PRELIMINARY  
BASIC ENVIRONMENTAL DATA

OCHRE RIVER  
BRIDGE

REFERENCE MILE 455 MACKENZIE HIGHWAY

DEPARTMENT OF PUBLIC WORKS  
EDMONTON, CANADA

MACKENZIE HIGHWAY  
OCHRE RIVER BRIDGE  
REFERENCE MILE 455

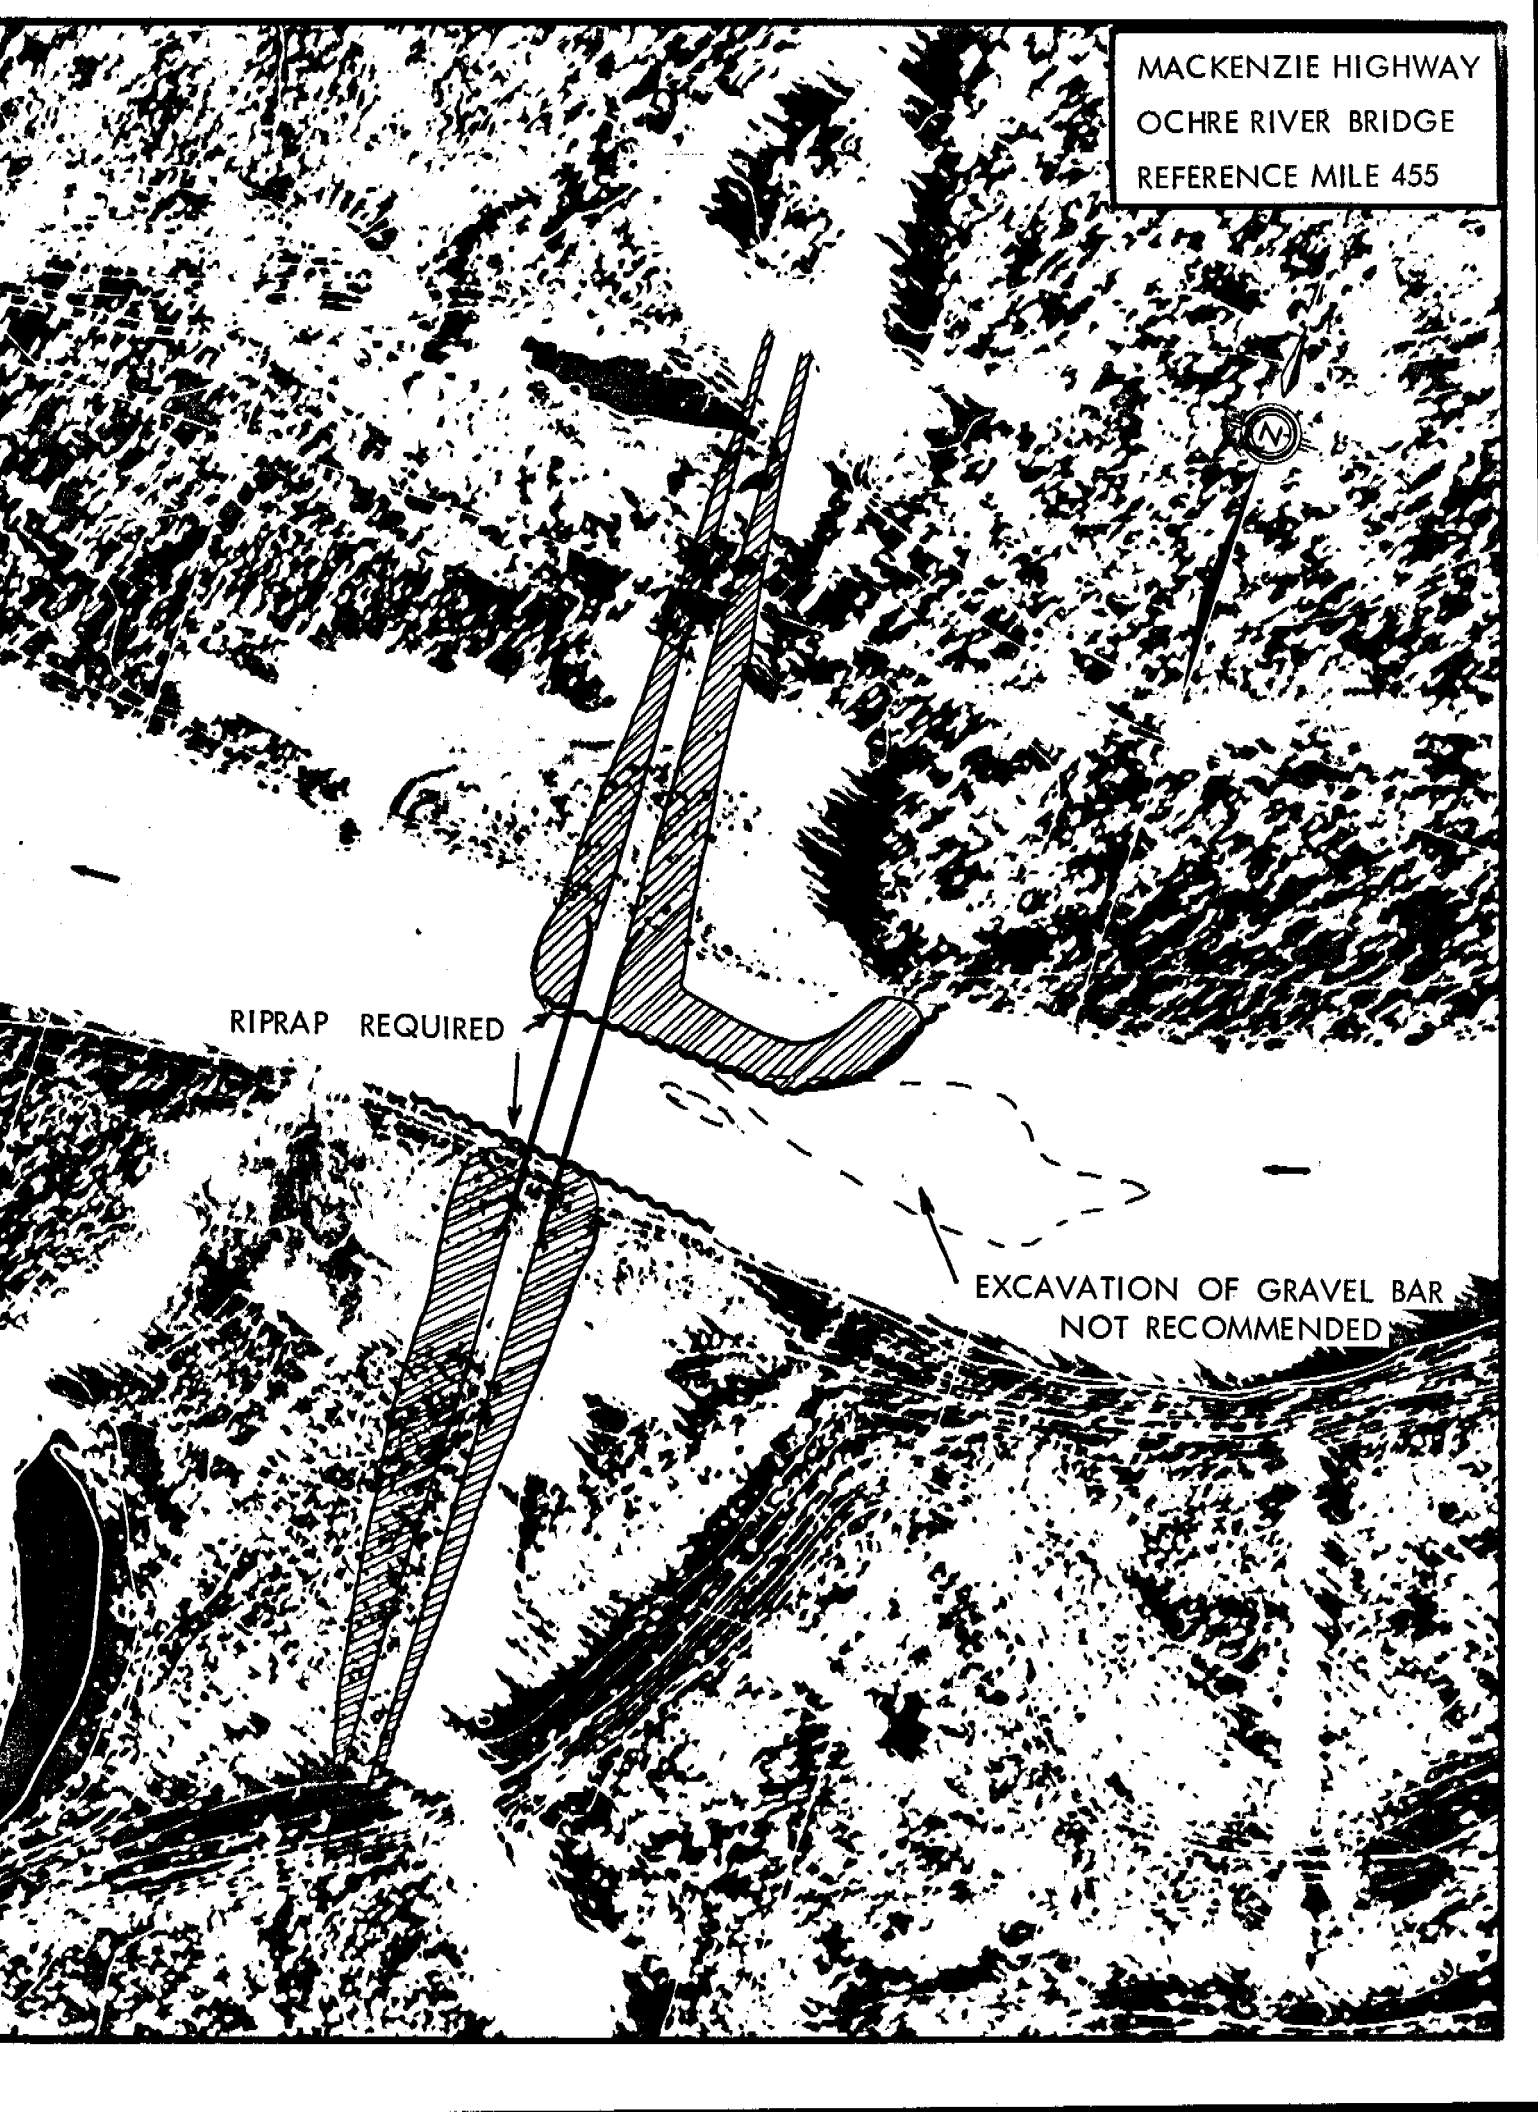
RIPRAP REQUIRED

EXCAVATION OF GRAVEL BAR  
NOT RECOMMENDED

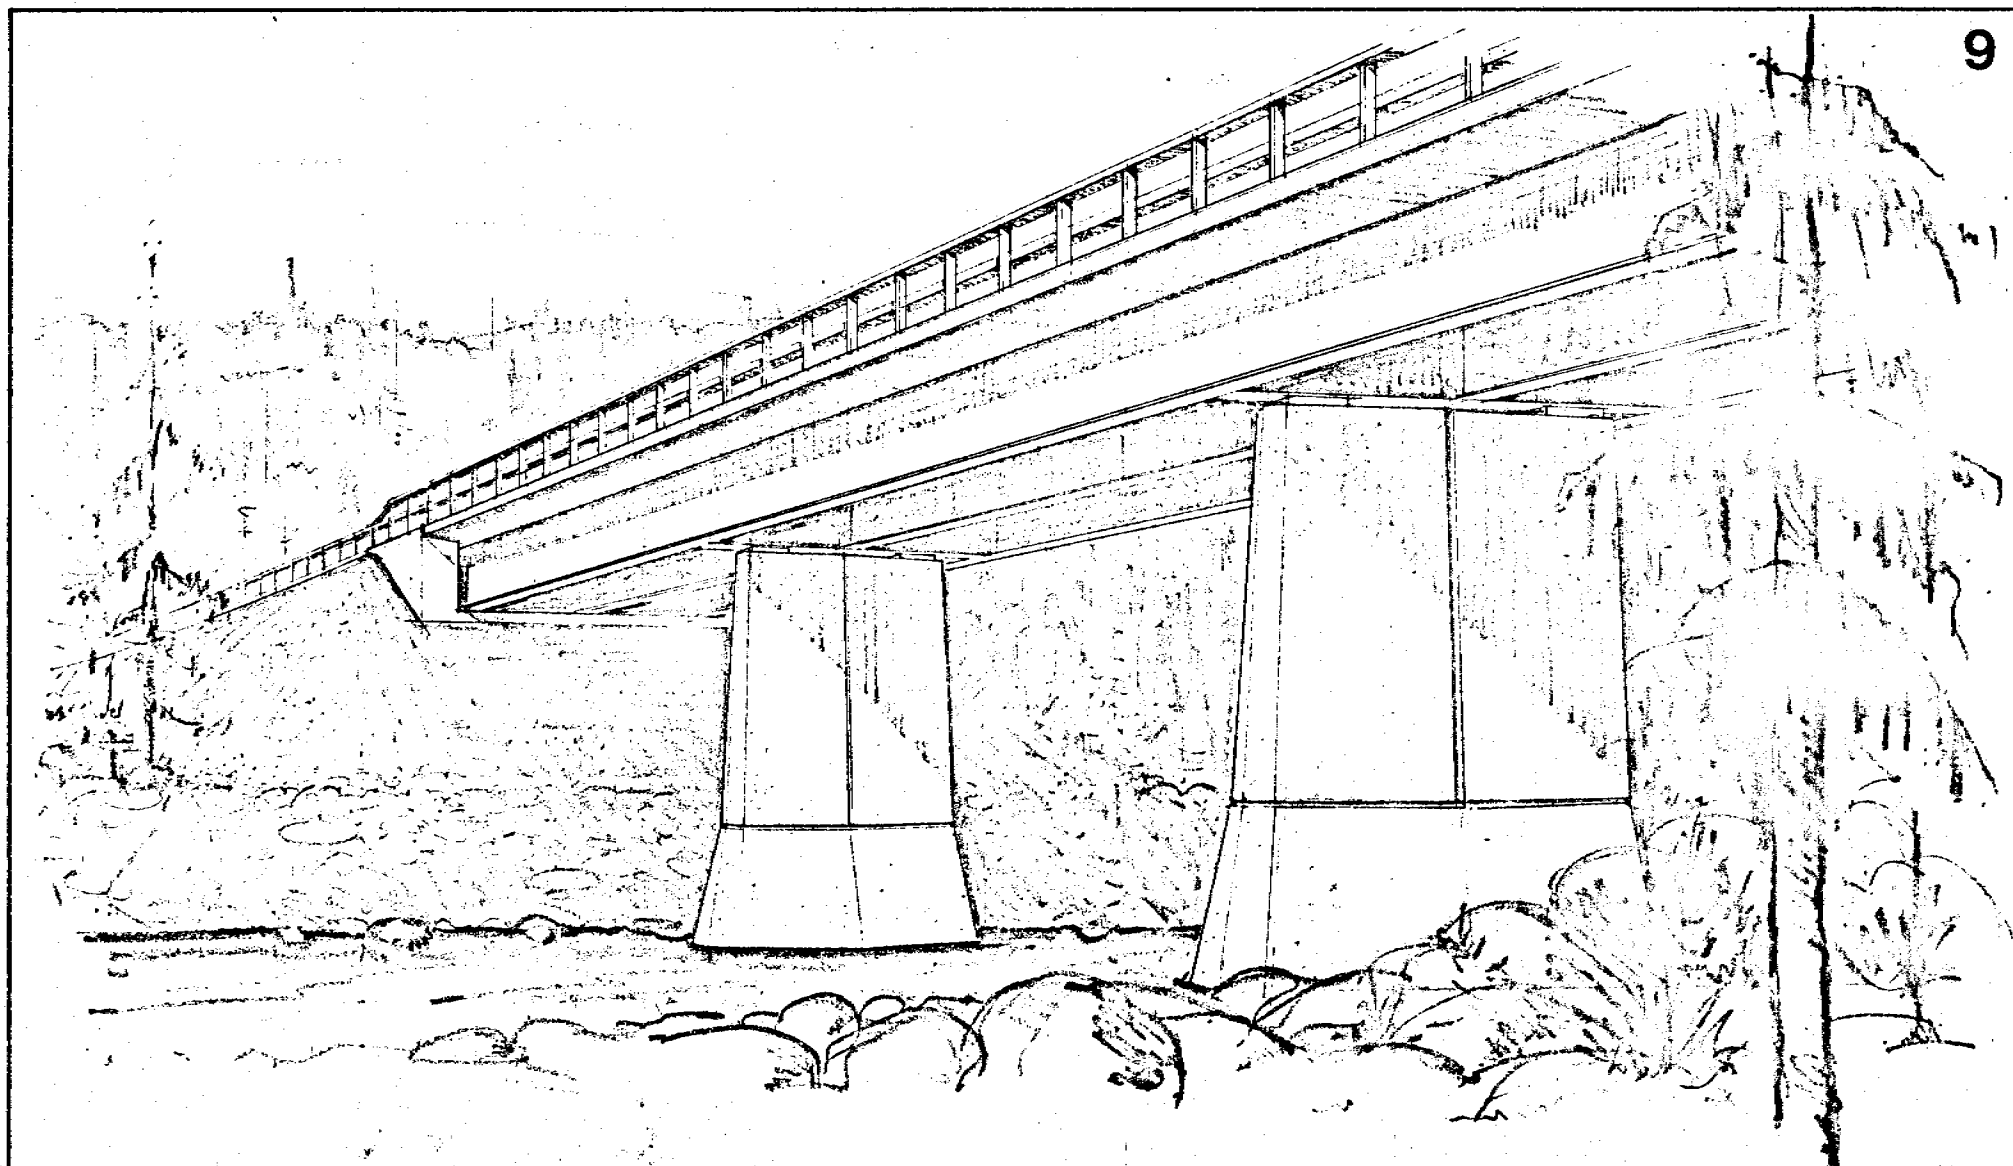
26.10.72. Ochre River. Known prehistoric site on downstream site of river mouth. Notice curve of thalweg; erosion most severe on southern side not on northern side as inferred in bridge report. Bridge footings should be on abandoned alluvial terraces, thereby eliminating special erosion prevention techniques.

OCHRE RIVER

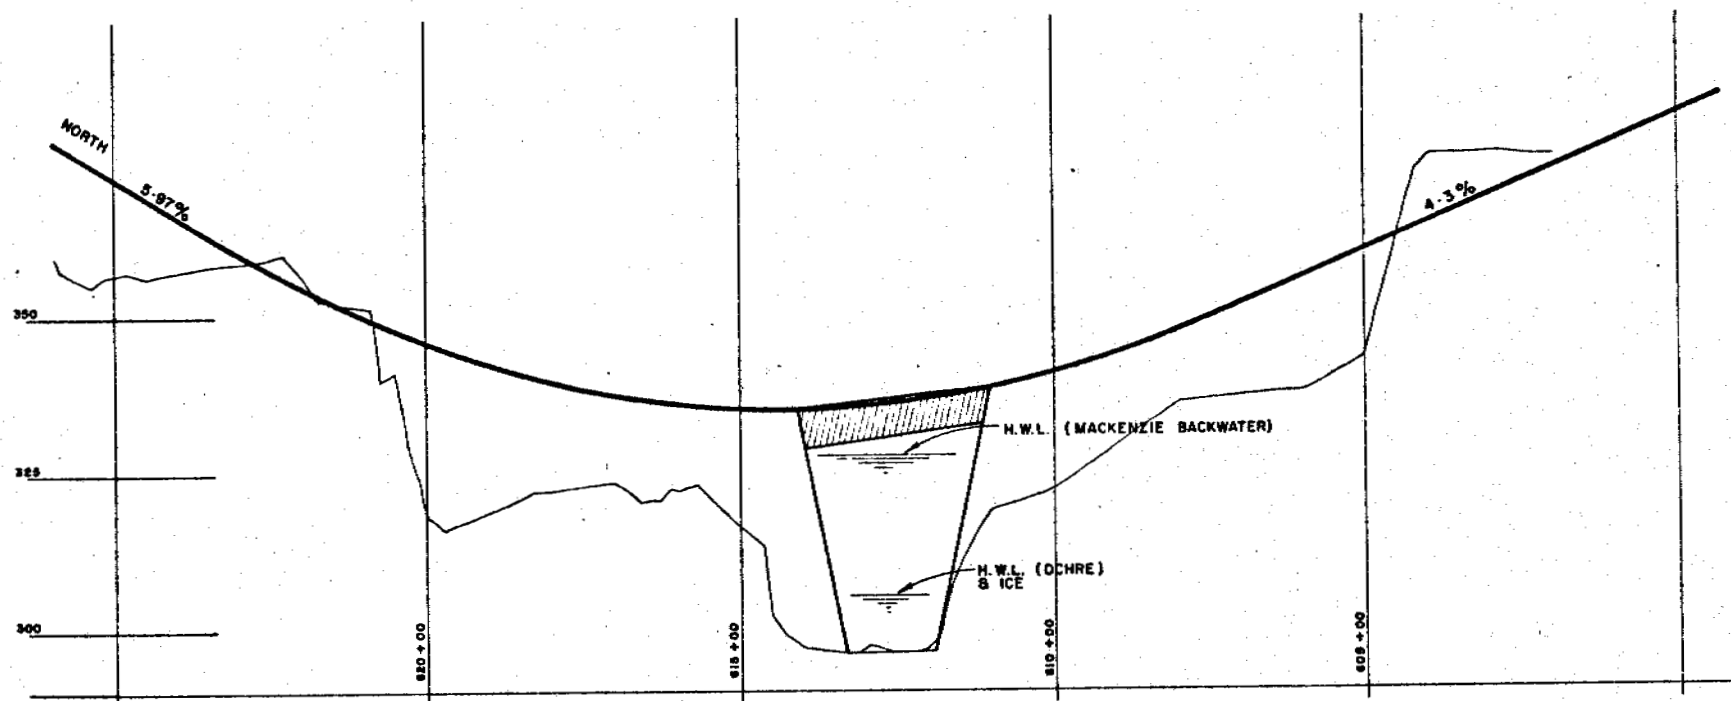
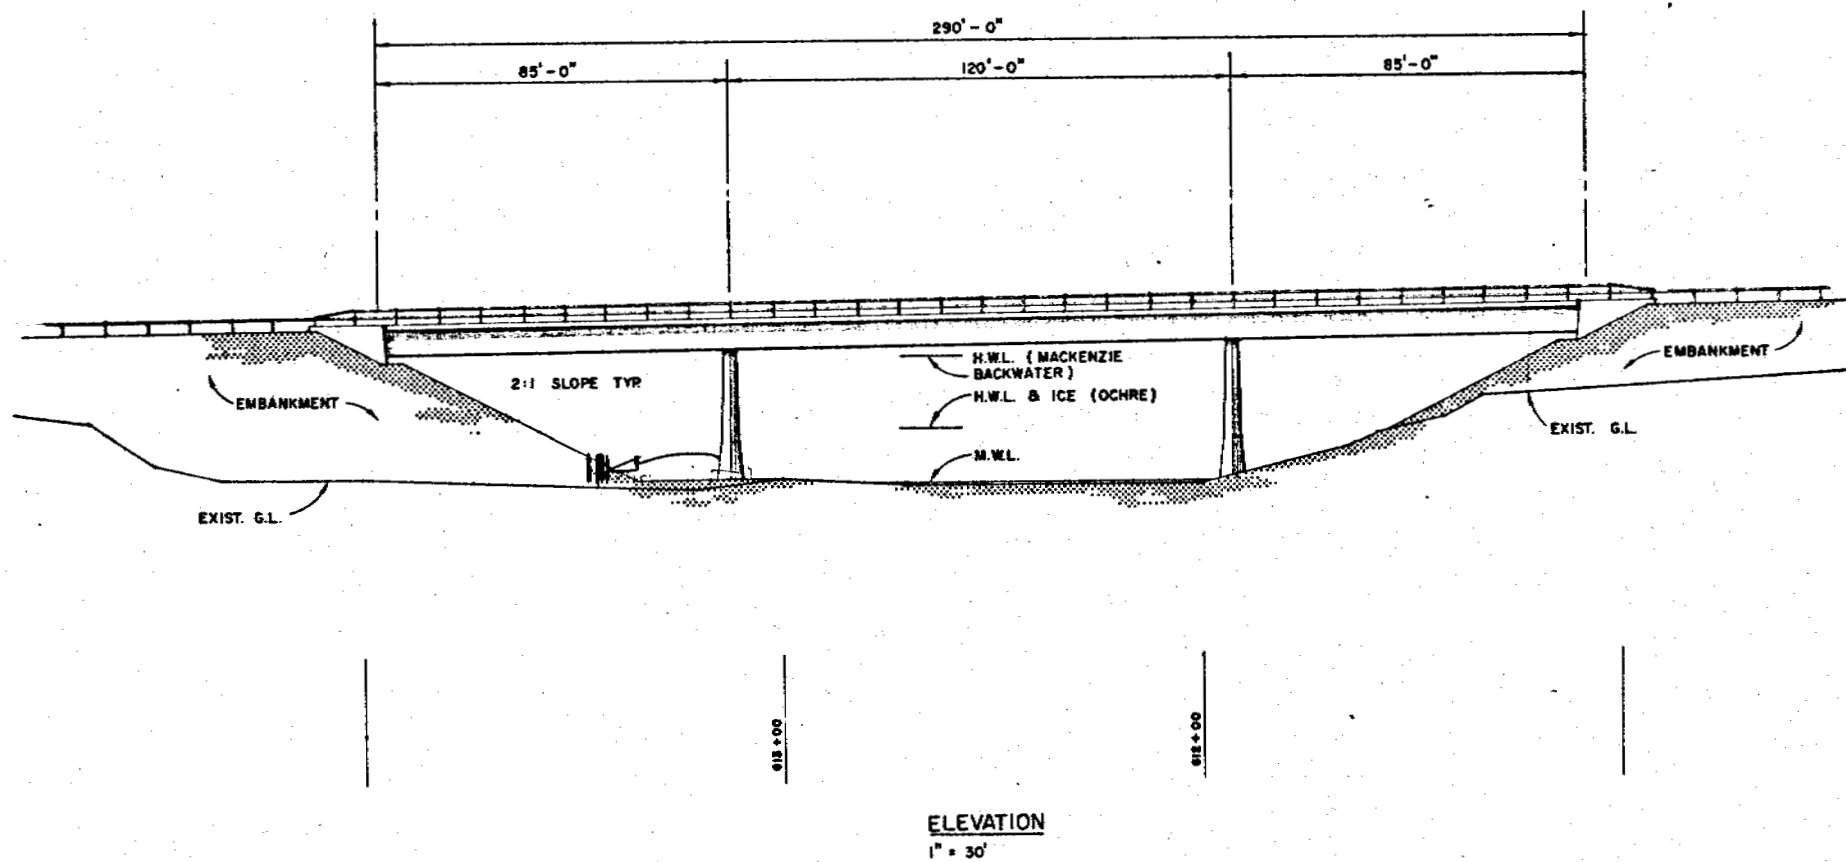
The bridge design planned for the Ochre River appears undesirable from the fisheries standpoint for several reasons. Most important of these is the removal of a large gravel bar upstream of the bridge site. Removal of gravel from the stream bed could be hazardous to the aquatic environment upstream and downstream.

The dyke itself, in association with the fill it protects, is also a matter of concern. The fills will encroach on almost half of the width of the stream bed. Velocities of the river at higher water levels should be calculated to ensure that excessive velocities are not created. Scouring of the stream bed upstream and downstream can also be expected if these plans are implemented.

Extensive riprapping of the proposed fills would be a major requirement.

Alternate bridge designs should be investigated to minimize adverse impact on fish.
